THE CLEVELAND ELECTRIC ILLUMINATING COMPANY

PY-CEI/NRR-0295 L

Perry Nuclear Power Plant
Docket Nos. 50-440; 50-441
Feedwater Isolation Valve
Testing (Question 480.50)

EDWARD FLITE FLOW DASH POT
CHECK VALVE GENERAL ASSEMBLY
SIZE 20.0" x 7" FIG. 7592 (HCC) JNGT

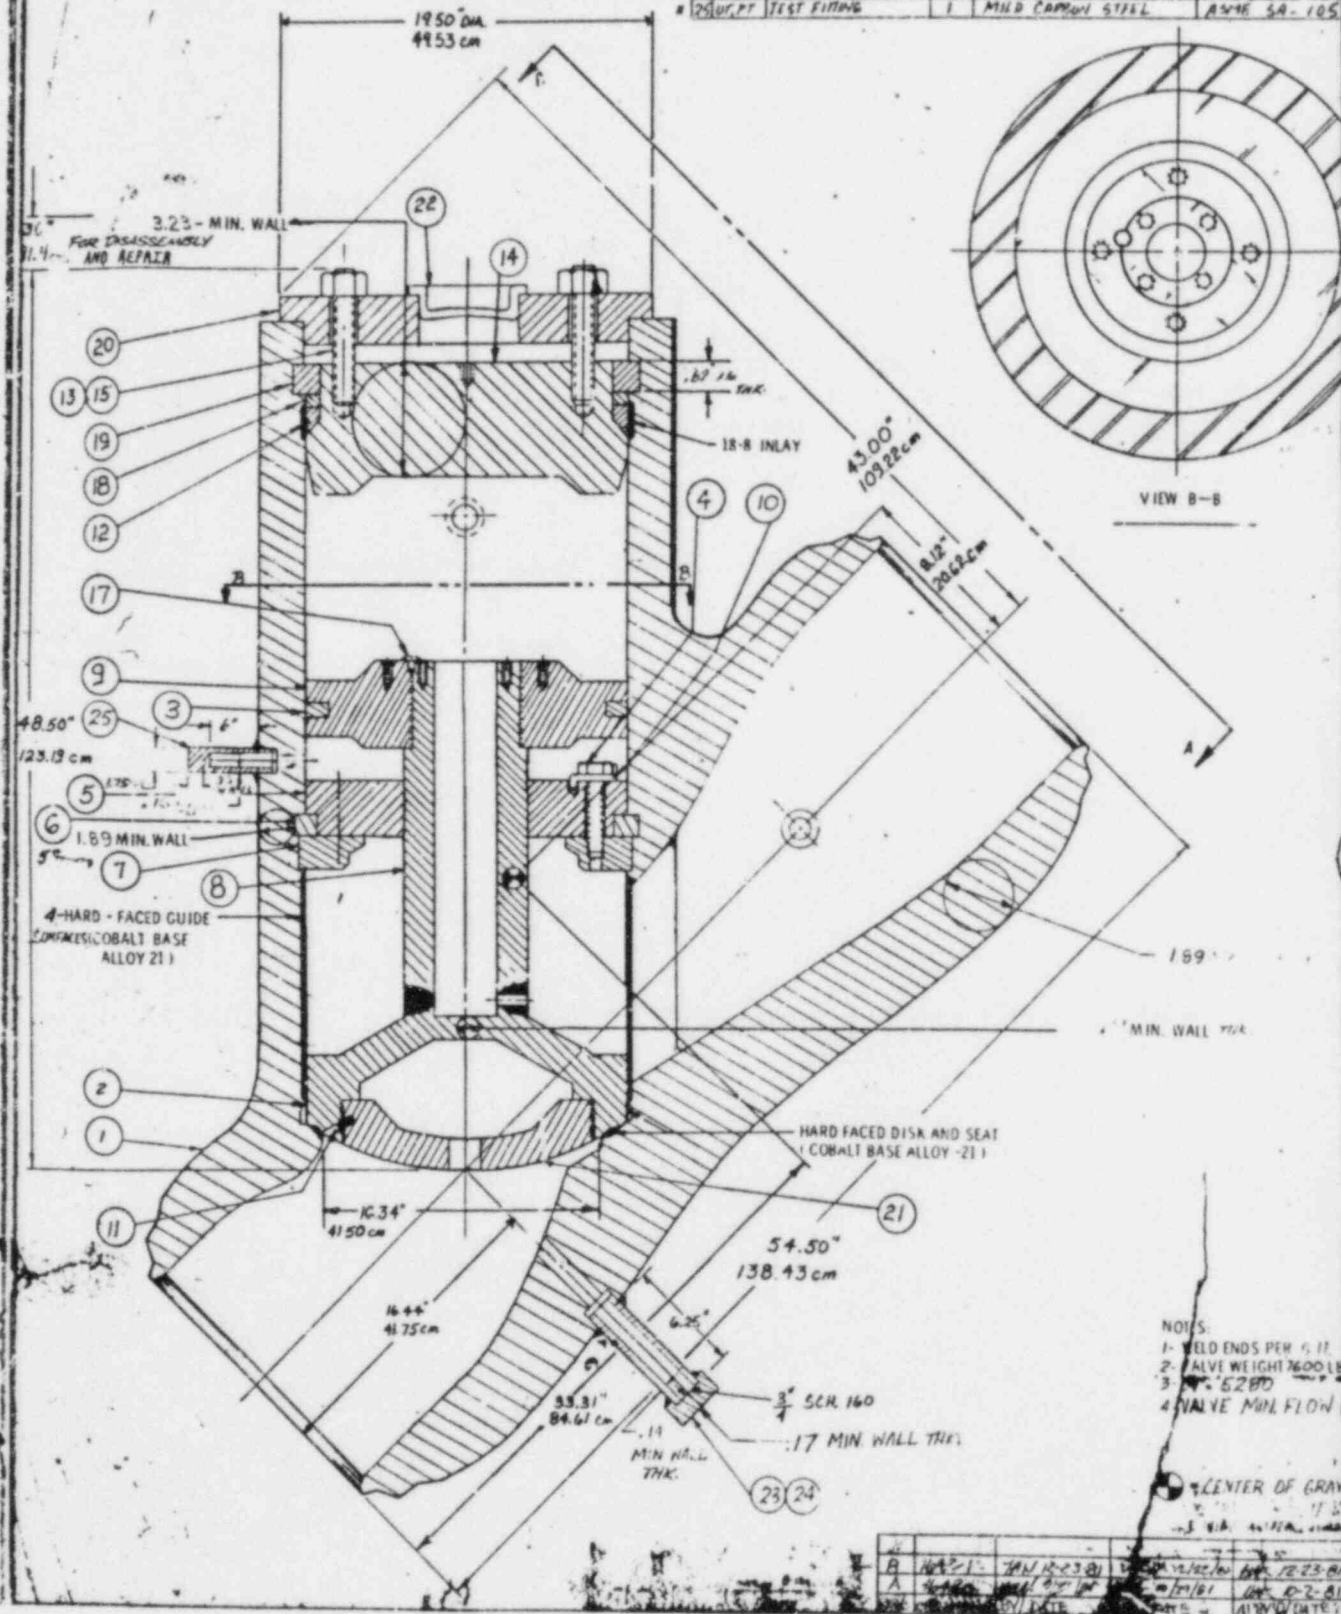
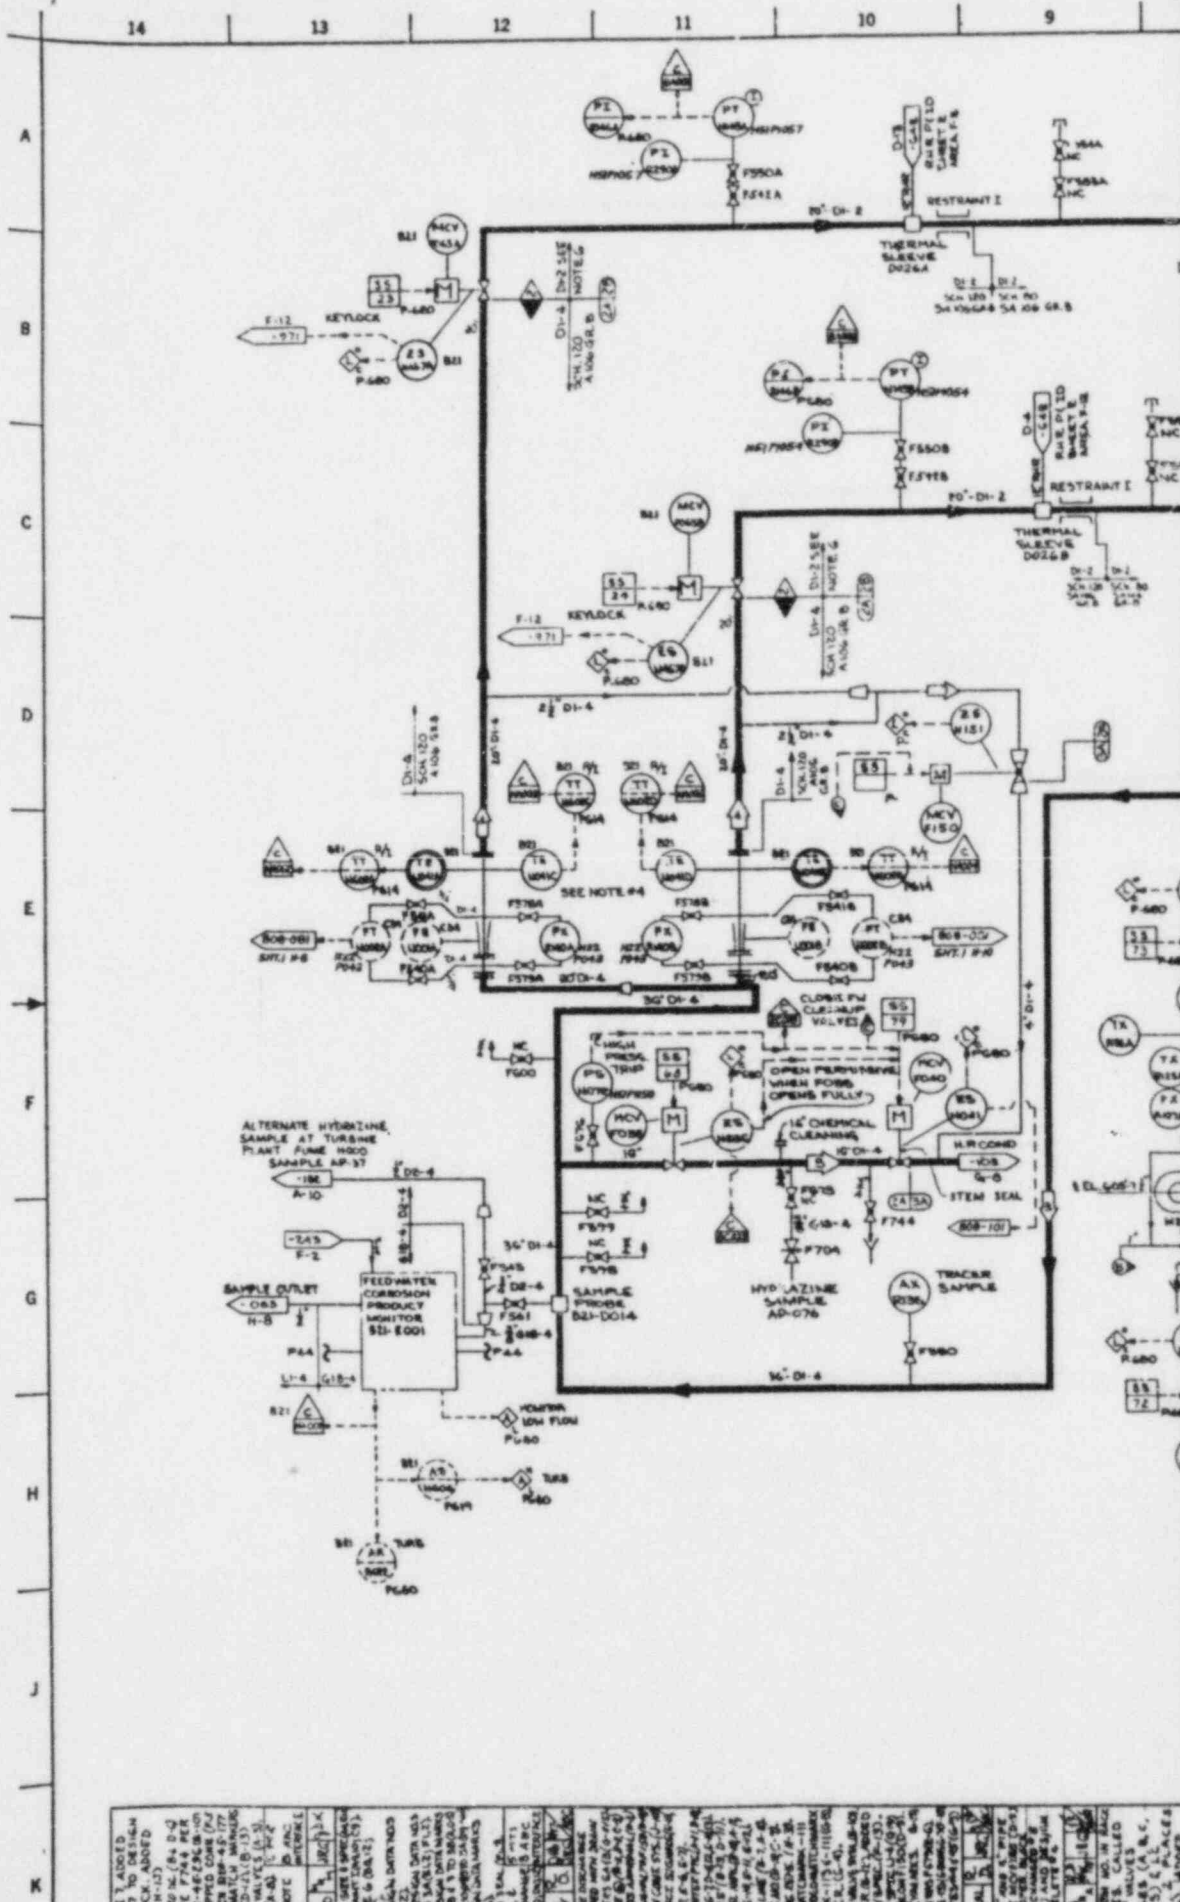
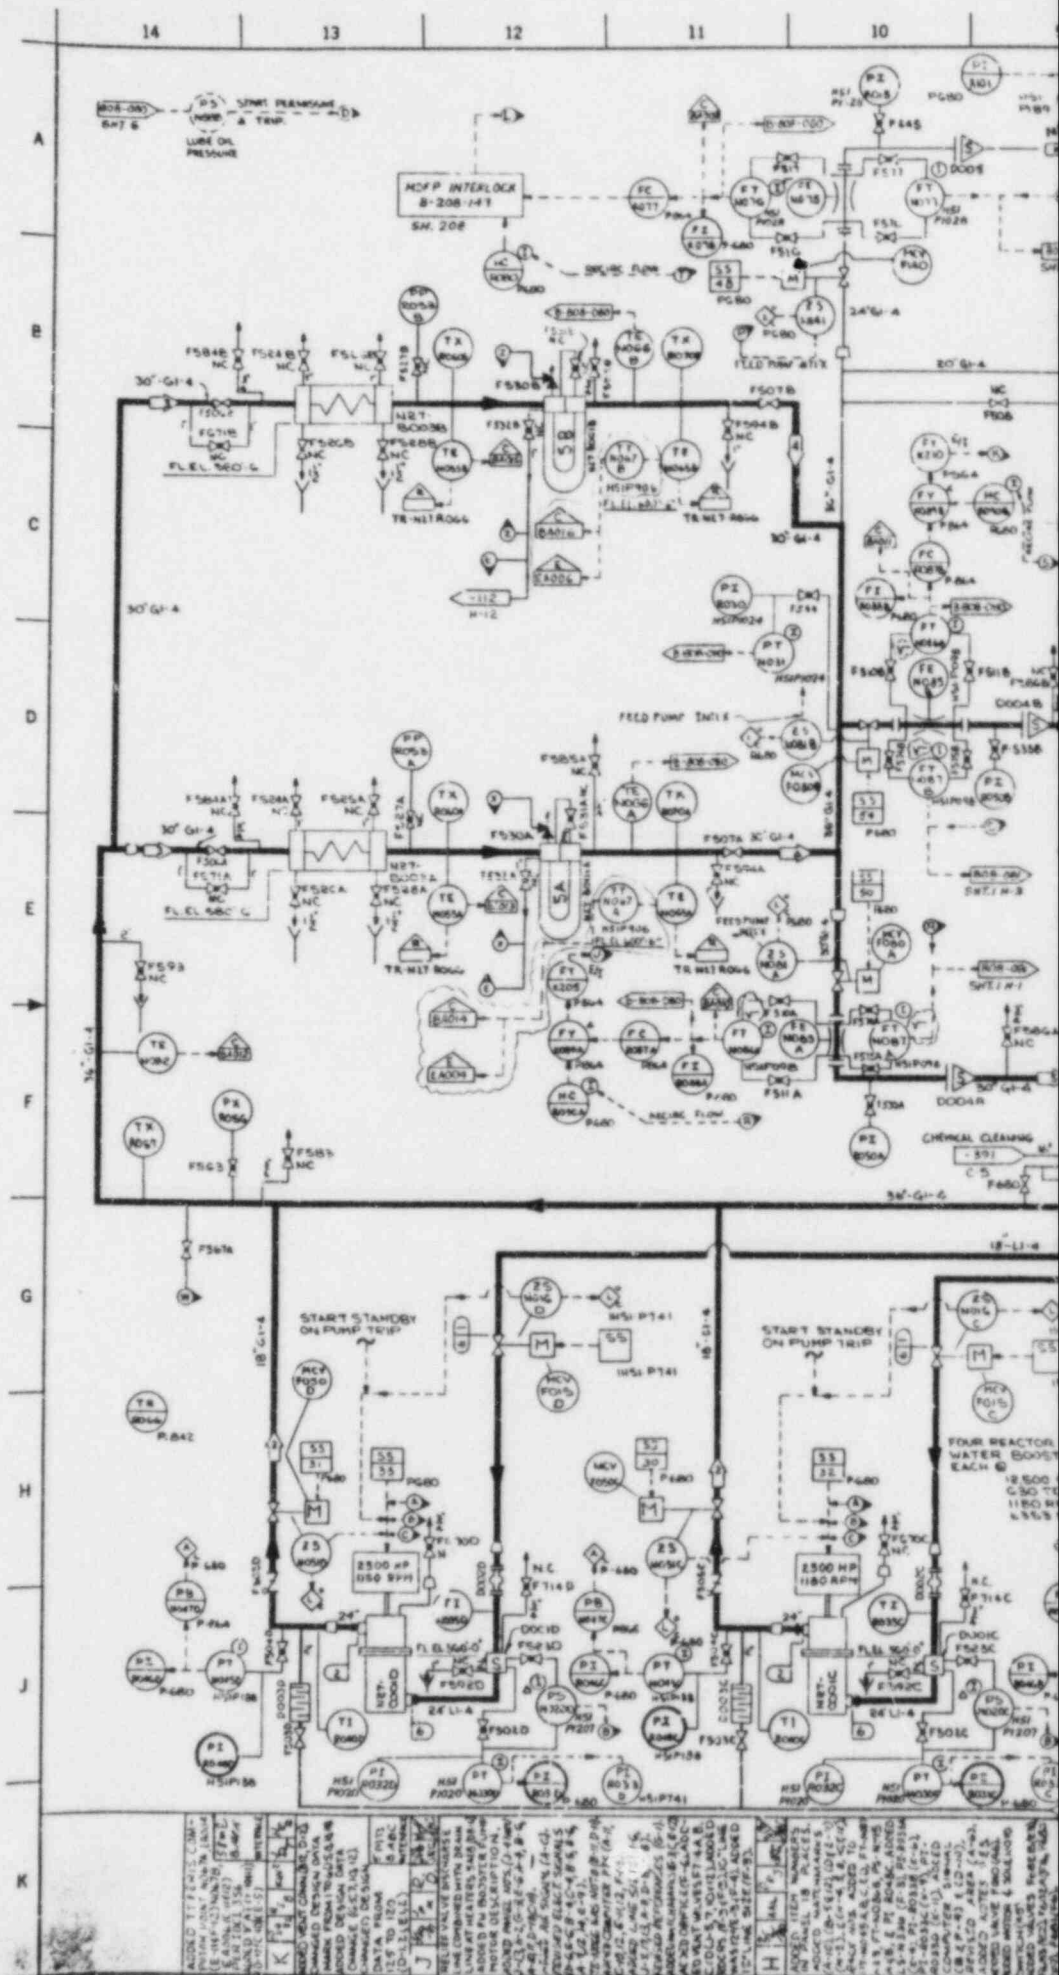
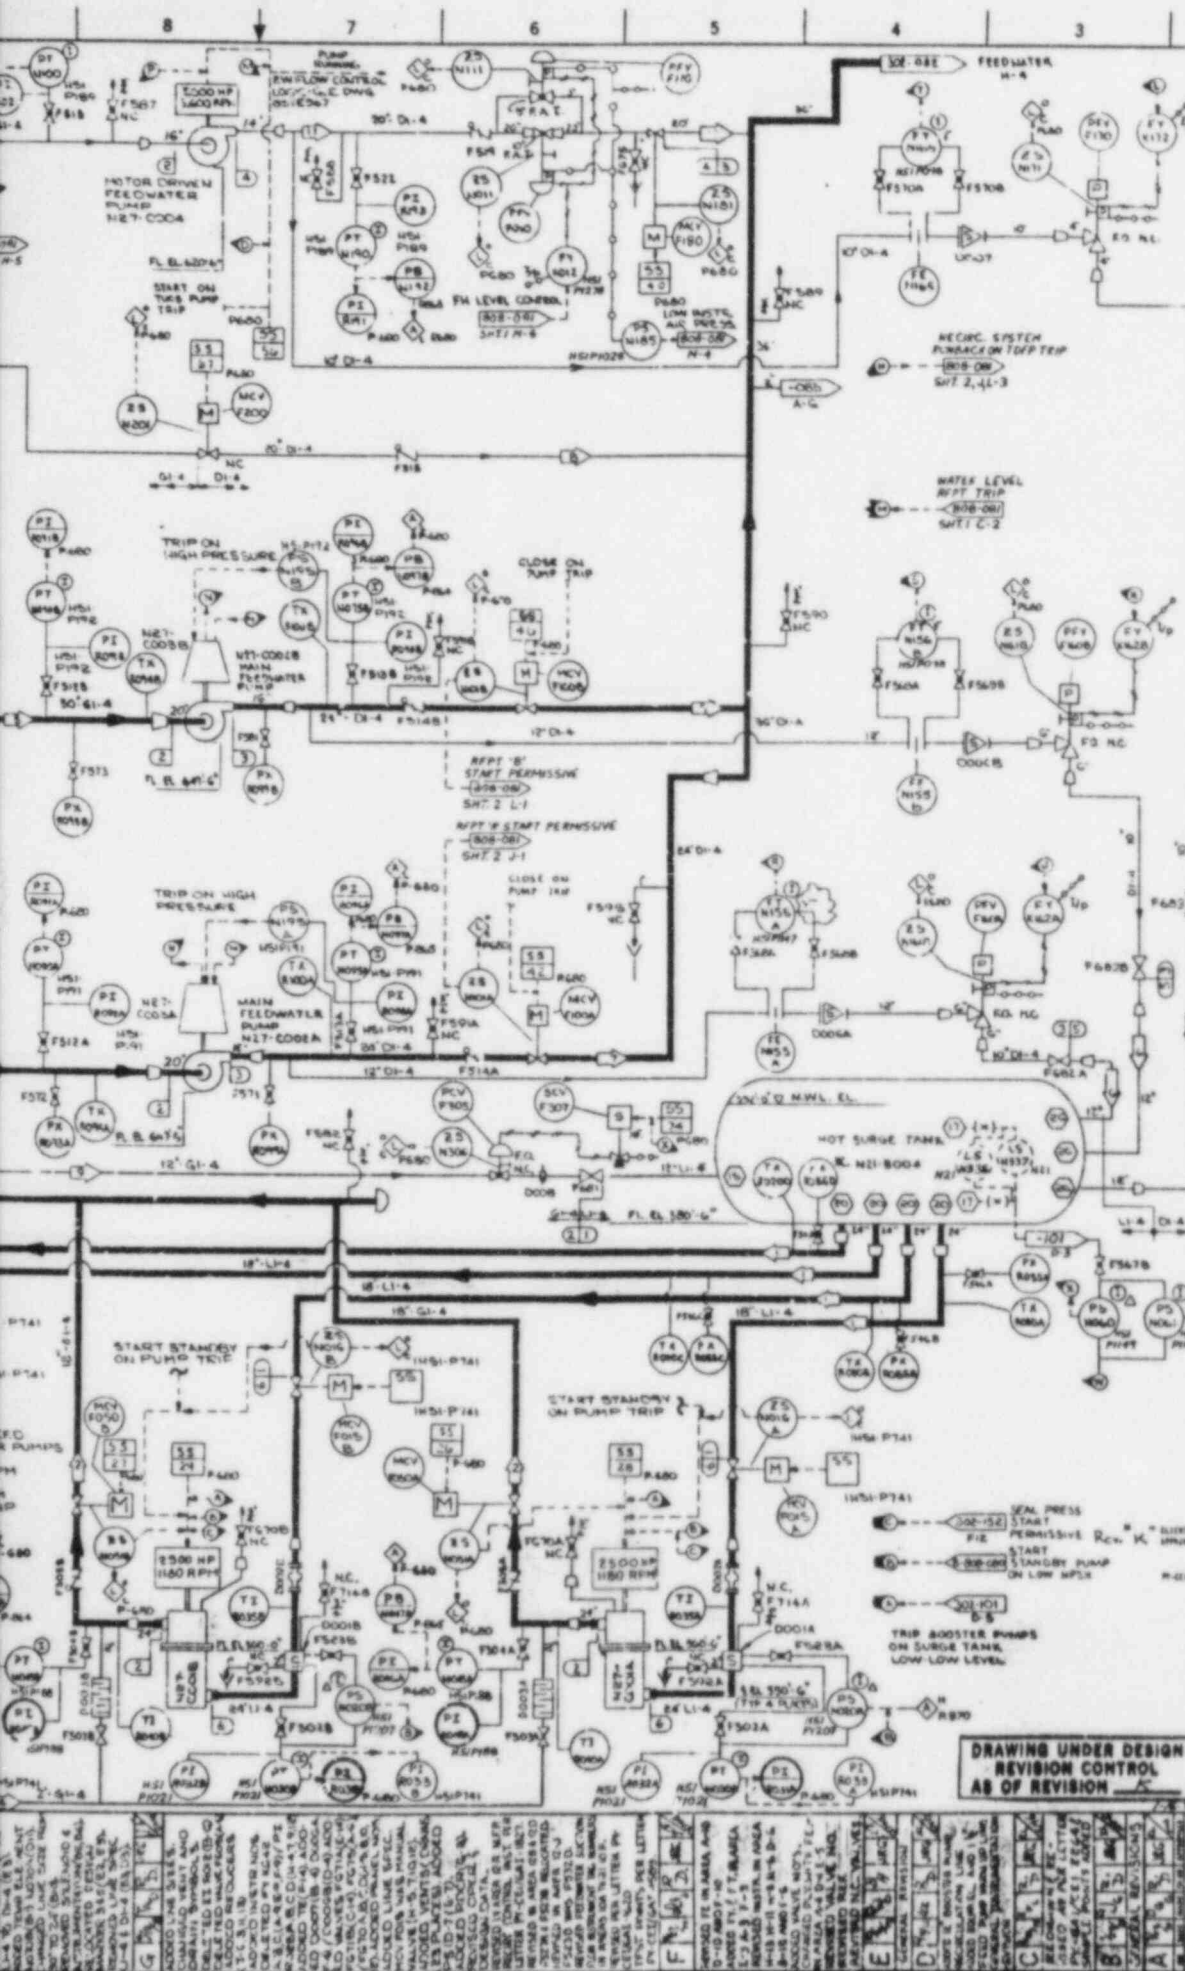
- a. CEI has indicated that the feedwater leakage control system (FWLCS) would provide post-accident sealing of both feedwater lines, thus precluding the need to perform Type C leak tests of the feedwater isolation valves with air. The Perry FWLCS is similar, if not identical, to the Grand Gulf FWLCS. At this time, MP&L (Grand Gulf) has not demonstrated satisfactorily that drywell leakage does not exist through the feedwater isolation valves in the first hour of the postulated event (i.e. time to manually activate FWLCS plus the time to fill the feedwater line). Therefore, the staff has required MP&L to Type C leak test these valves with air. Similarly, the staff will require CEI's feedwater isolation valves to be leak tested with air or demonstrate why these valves should not be tested with air.

Stem leakage is not considered a leakage source because the stem is not exposed to the environment (refer to drawing 40-1012-1). The valve stem & disc are totally enclosed within the valve body and bonnet. Therefore, motion between the stem & bonnet will not result in bypass leakage. The bonnet is flanged and gasketed. The flange is tightened down to allow zero leakage at feedwater pressure and would not leak at the post LOCA drywell pressure (peak and steady state).

Refer to the enclosed valve drawing 40-1012-1.

The feedwater isolation check valve is an anti-water hammer lift check type, designed to seal against water pressure.

The anti-water hammer design was specified to minimize the forces resulting from check valve closure due to a feedwater line break outside containment. The moving portion of the valve consists of a disk, tube and piston. As the valve closes, water from below the piston is forced out of a cavity above the dash plate. The water is forced through the small annular space between the dash plate opening and the tube. The small annular space acts as a flow restrictor, resulting in the necessary damping.

The valve sealing surfaces were designed to seal against water. Water was specified as the leakage medium after we incorporated a Feedwater Leakage Control System which would ensure a long-term safety-related water seal. The disk and seat mating surfaces are hard-faced. The hard seats provide an appropriate barrier to water leakage. Also, the width of the seat results in bearing stresses suitable for sealing against water.
